ADDENDUM NO. 3

**SPIETH HALL ROOF REPLACEMENT AND
MECHANICAL UPGRADE**

PROJECT NO. 950599

Subject: UCR Spieth Hall Roof Replacement & Mechanical Upgrades - Addendum #3

FILE 120-07-05
DATE 05-09-22
DRAWING NUMBER SK-1

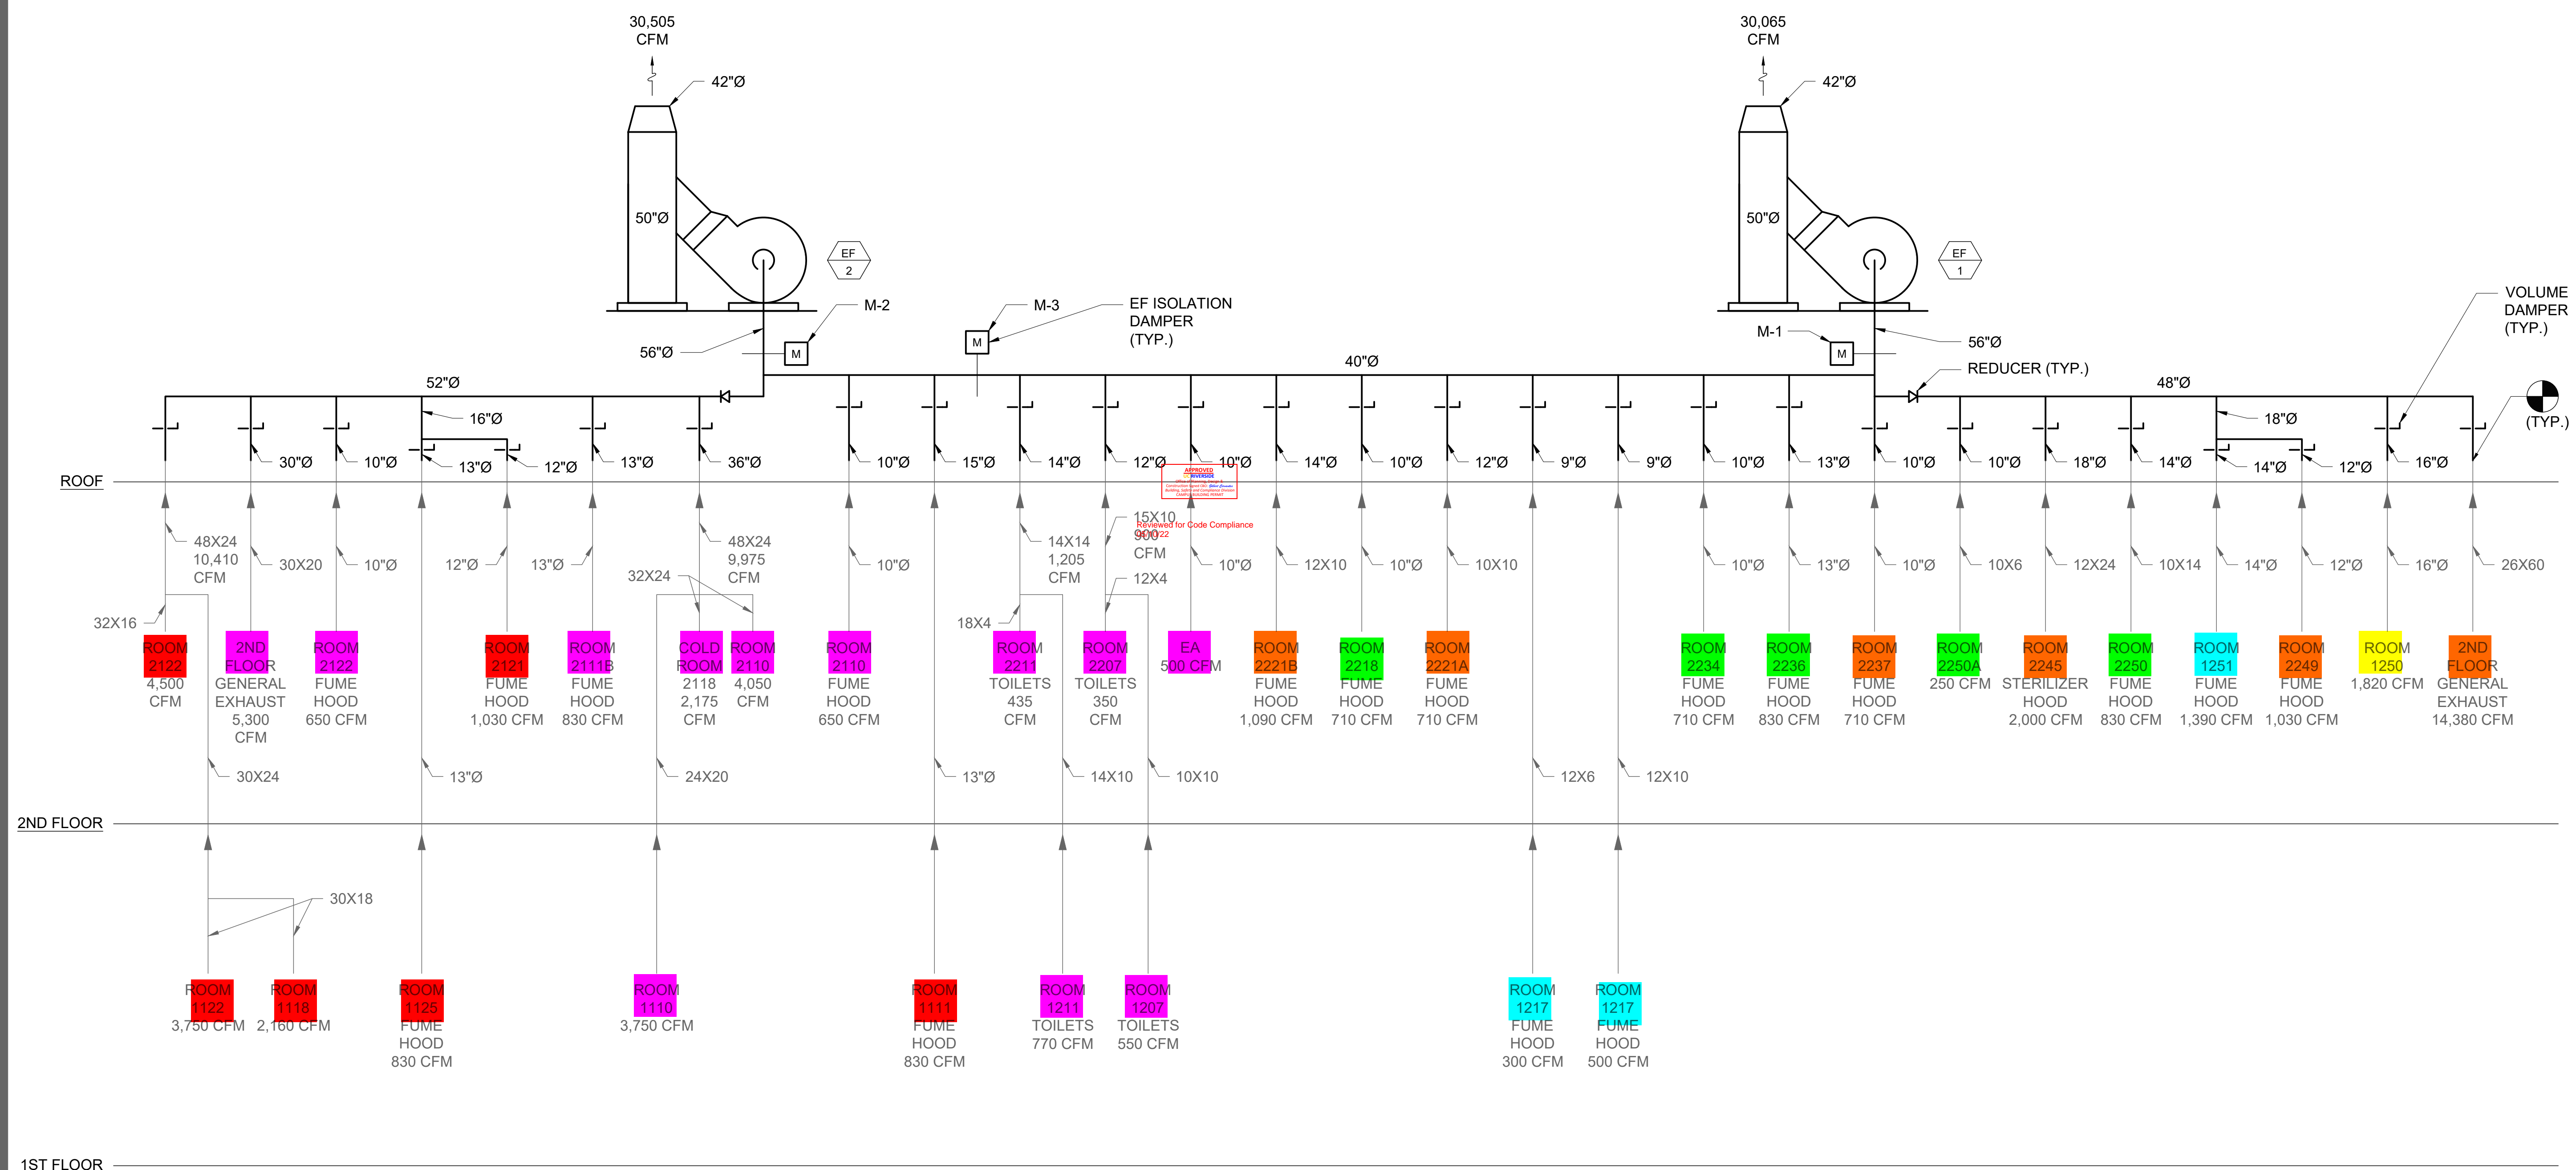
SK-1:

1. Phasing plan to allow maximum 12-hour shutdowns.

- 1. Max 12-hr shutdown per section

PIPING SUPPORT DETAIL (N.T.S.)

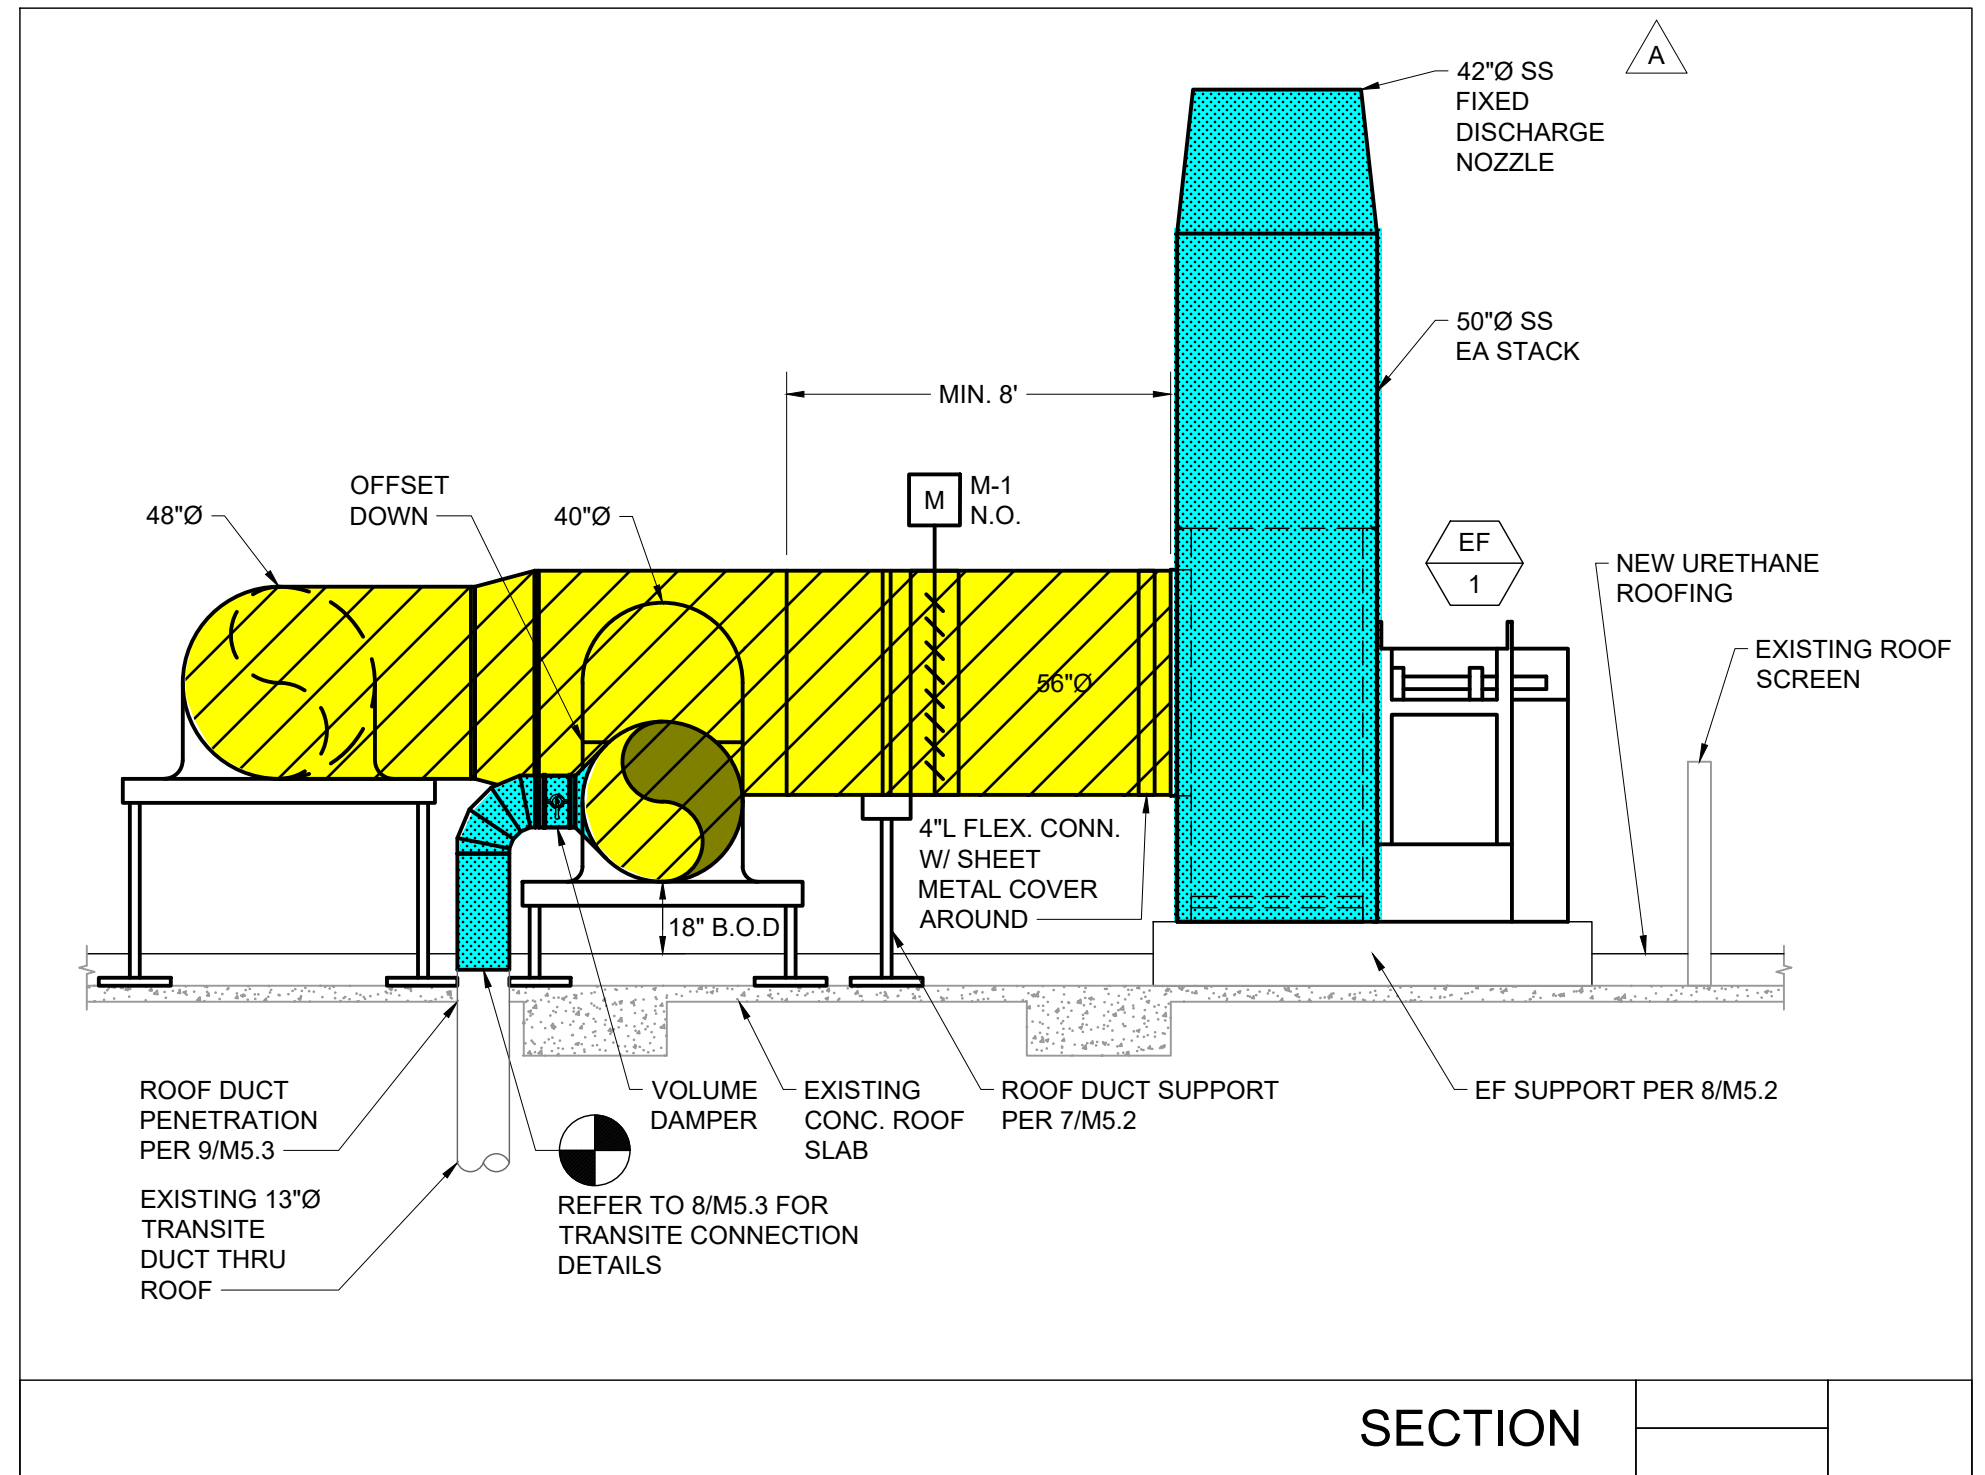
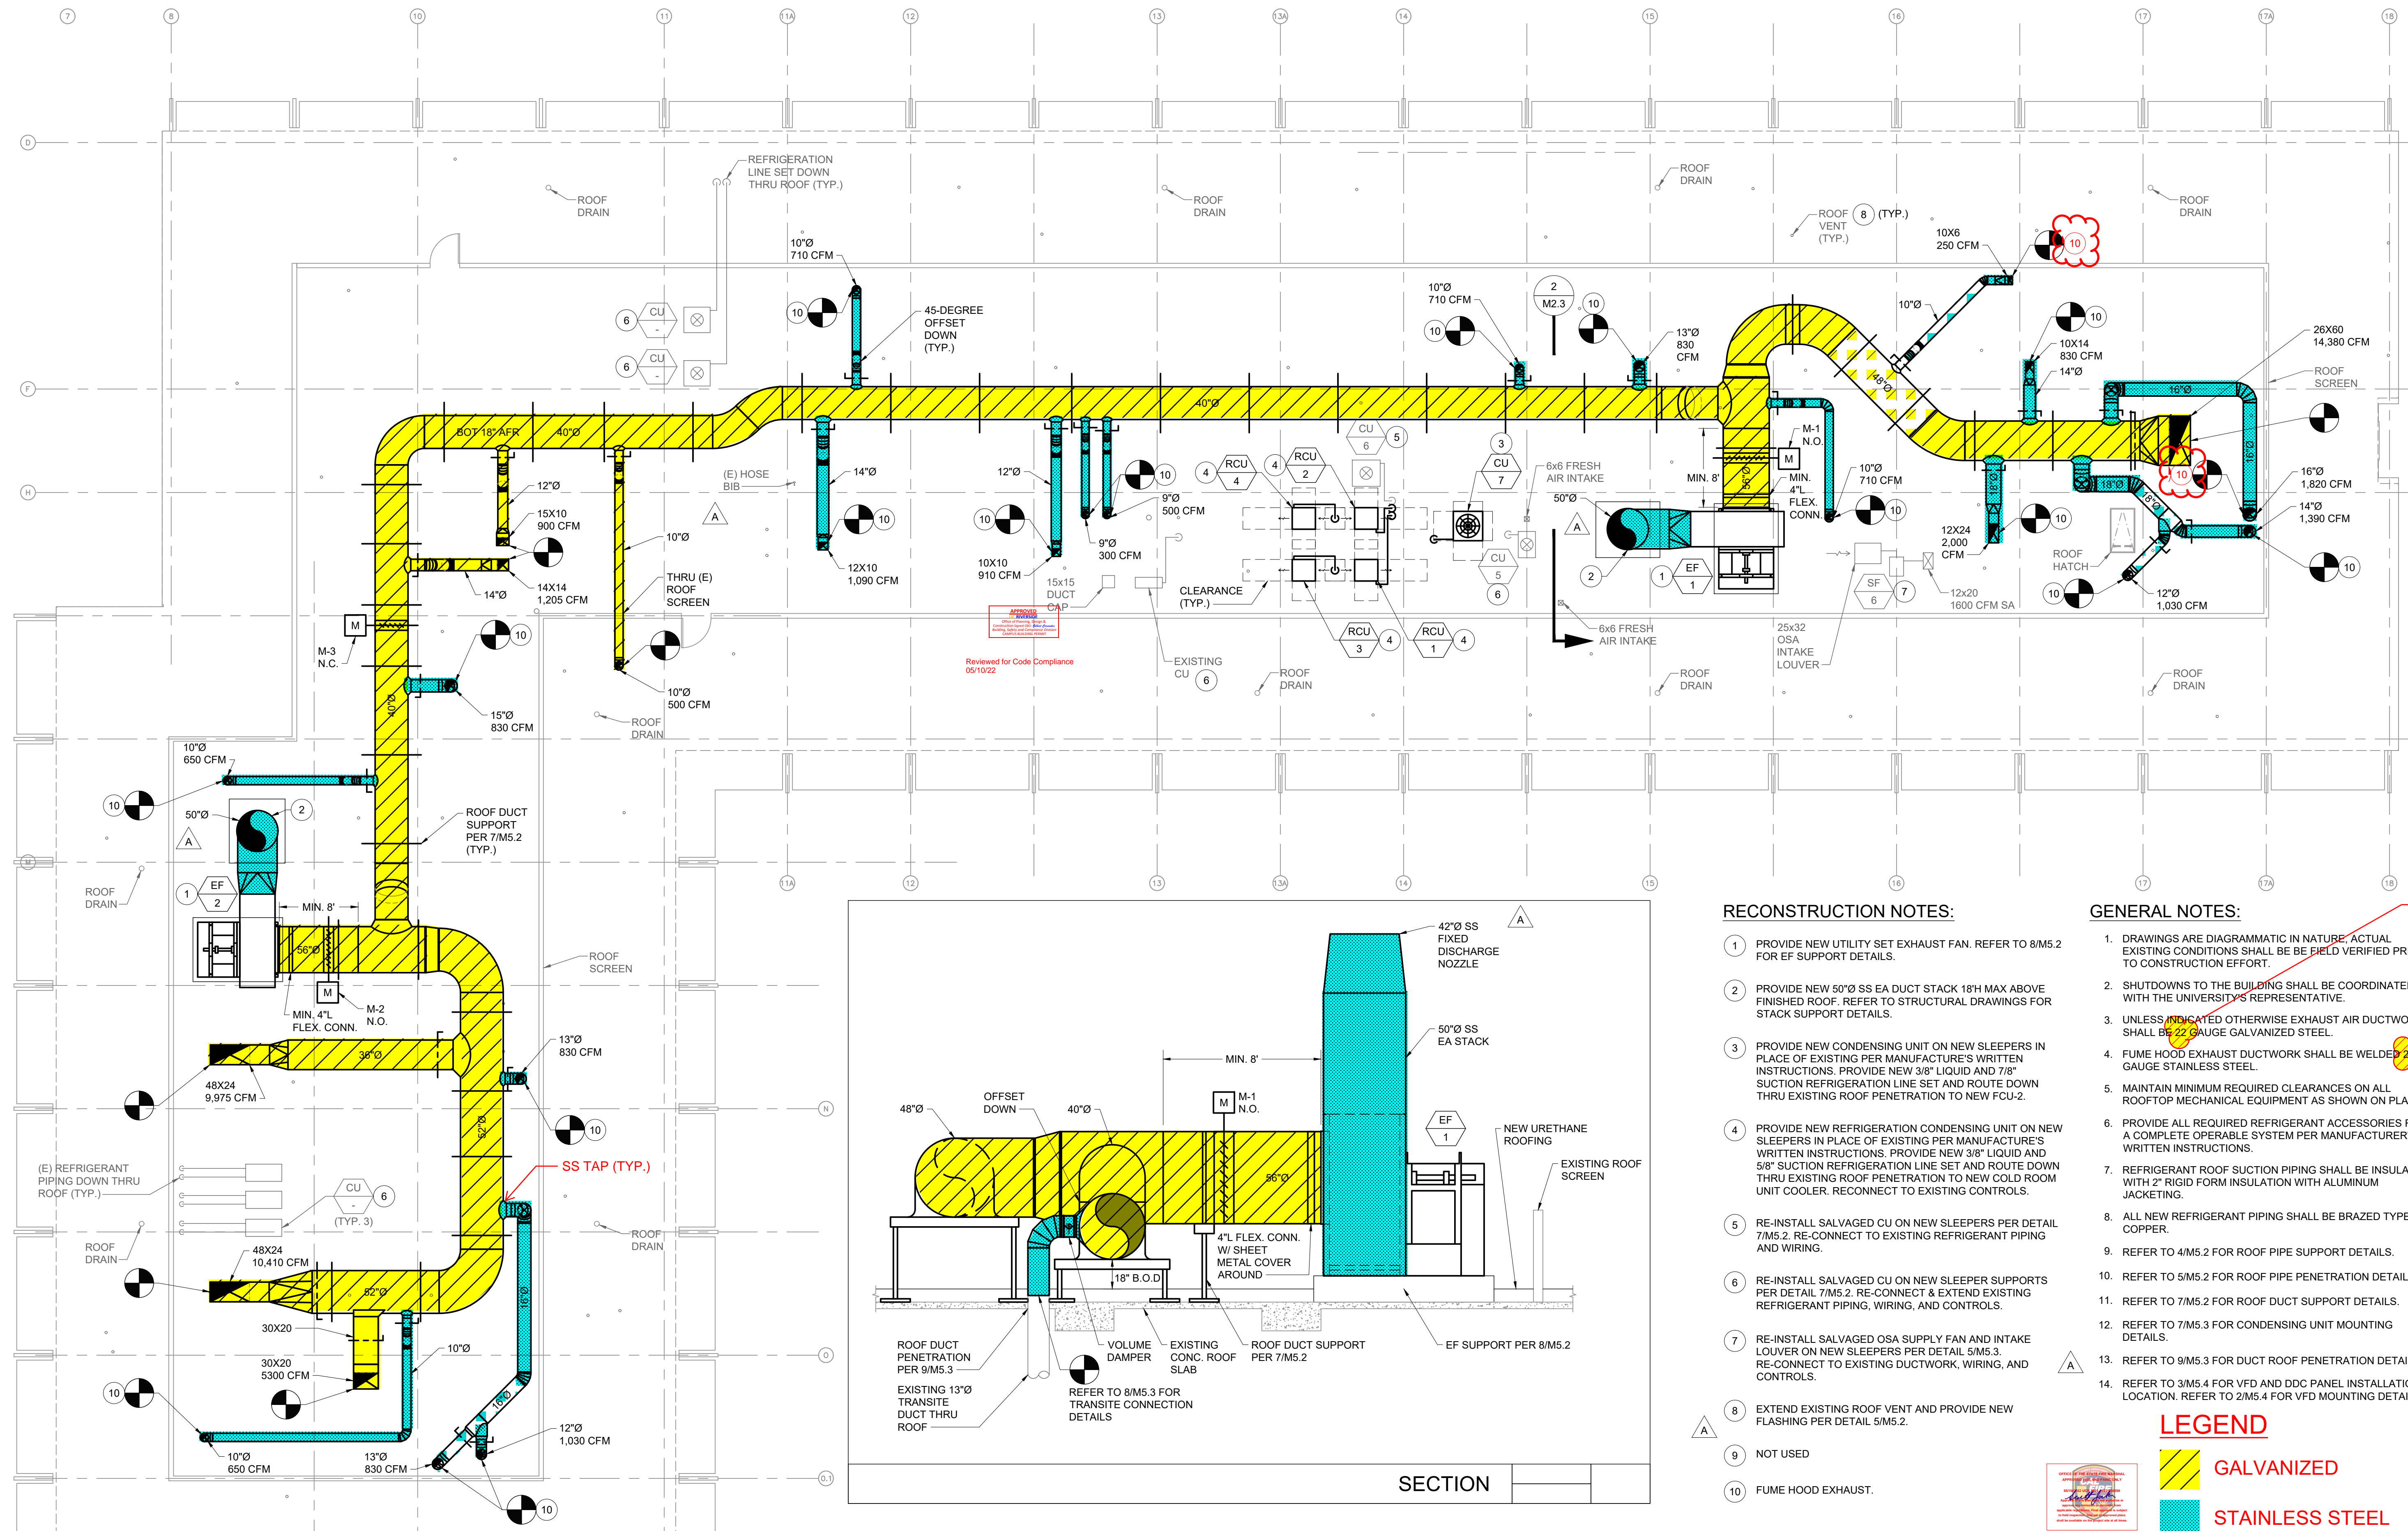
<p>3-5</p>	<p>Question: Per Drawings M1.1 and M1.2, Grids 14xH 3 pair of refrigeration lines going from first floor to the roof. See attached snip. During the job walk they did not look like they are visible, but are they inside a shaft? If they are inside a shaft, access will be required, so would provide a detail on <u>how will they be supported?</u></p>  <p>Answer: Existing refrigerant pipe riser is located within wall shaft. Contractor shall cut opening and patch and paint wall to match existing. Support vertical refrigerant piping at floor level per attached sketch SK-2.</p>
<p>3-6</p>	<p>Question: Per drawing M2.3, General Notes, #4: Fume hood exhaust ductwork shall be welded 24 gage stainless steel. Spec section 23311-3, 2.2, C shows that minimum 18 gauge 24 gauge is very difficult to weld and it will look really bad, we recommend minimum 18 gauge SS.</p> <p>Answer: Provide minimum 18-gauge welded SS ductwork per SMACNA.</p>

SK-2:

1. Piping wall support detail for new refrigerant piping in existing shaft riser.

ROOF EXHAUST DUCT MATERIAL TYPES
 ADDENDUM #3

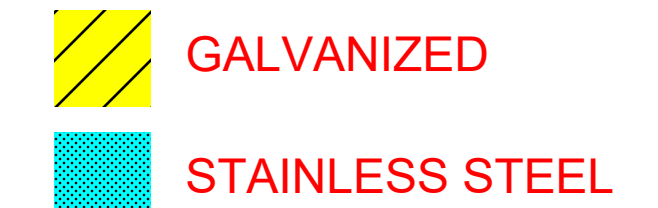
<p>3-7</p>	<p>Question: Spec Section 23311-3, 2.2, C shows that we are to use for exposed duct 316L with 4 finish is a brush finish which is extremely expensive and requires much more labor and it would be a waste to have it on the roof. Since this duct is on the roof and exposed to weather, can we use 304 SS or 316 SS ductwork with 2b finish?</p> <p>Answer: Provide 316L SS with 2B finish. 304 SS is not acceptable.</p>
<p>3-8</p>	<p>Question: Please clarify if Ductwork connected to room 2245 Sterilizer Hood needs to be welded SS ductwork?</p> <p>Answer: Exhaust branch ductwork serving Room 2245 Sterilizer Hood shall be welded stainless steel per plan.</p>
<p>3-9</p>	<p>Question: Per M5.1, and M2.3, most of the branches are welded stainless steel ductwork However; main ducts on the roof are 48", 40", 52", 46x60 between grids 17 & 17A and 48x24 between grids 7 & 9. See attached highlighted ductwork. Will the main ducts above need to be welded SS or just galvanized?</p>  <p>Answer: All galvanized ducts shall be minimum 18 gauge and constructed of -10 in. w.g. per SMACNA and Specification Section 23 3113. Refer to attached sketch SK-3 for duct material types.</p>

SK-3:

1. Roof exhaust duct construction material clarifications.

18 GAUGE GALVANIZED STEEL

18 GAUGE STAINLESS STEEL
